Airworthiness Directives; Eurocopter France Model AS355E, F, F1, F2, and N Helicopters

ACTION: Notice of proposed rulemaking (NPRM).

Eurocopter France: Docket No. 2003–SW–10–AD. Revises AD 2003–21–09, Amendment 39–13344.

Figure 1

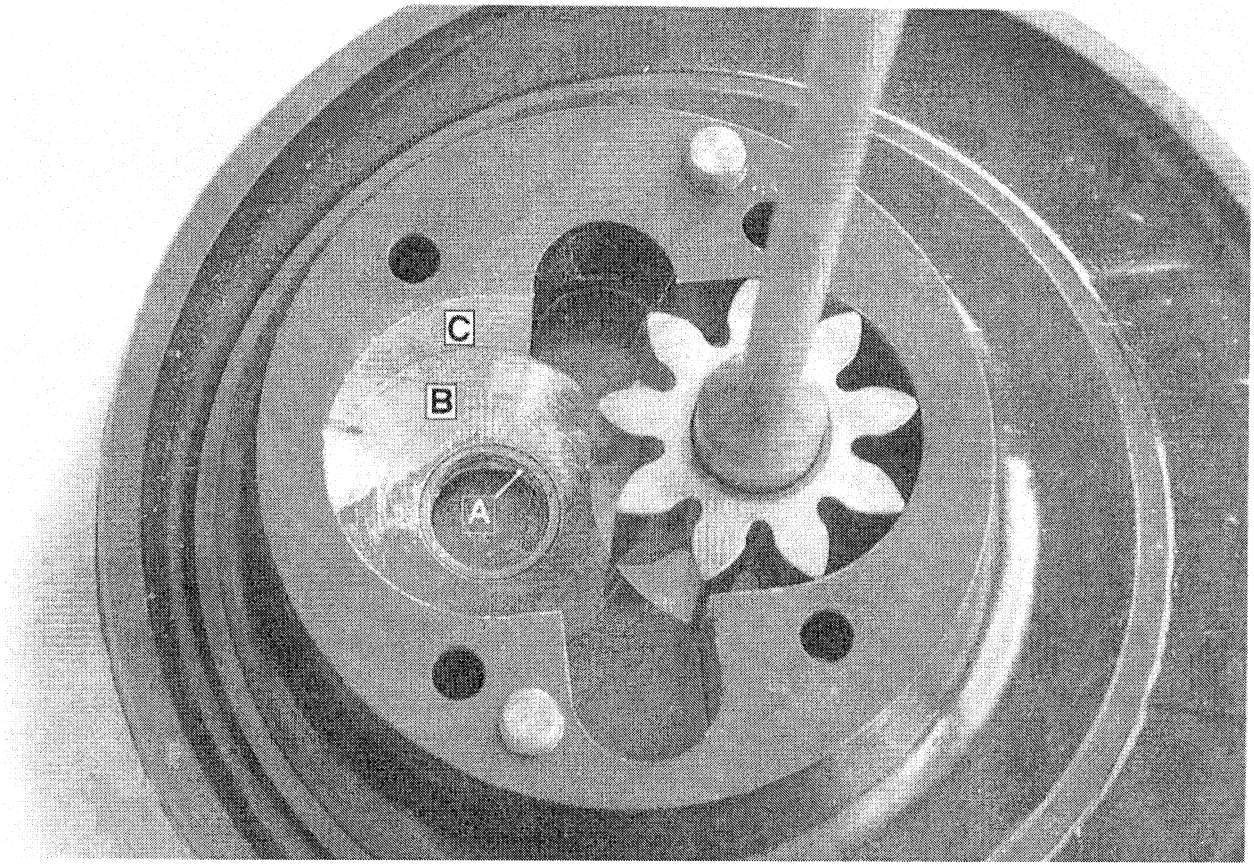
(d) While inspecting the pump, if you find any of the following, replace the MGB and the pump with an airworthy MGB and pump before further flight:

(1) Crank pin play,

(2) Out of round bronze bushing (A of Figure 1),

(3) Offset of the driven gear pinion,

(4) Metal chips, or

(5) Wear (C of Figure 1).

Note 2: If wear is present in the B area only as depicted in Figure 1, replacing the MGB and the pump is not required.
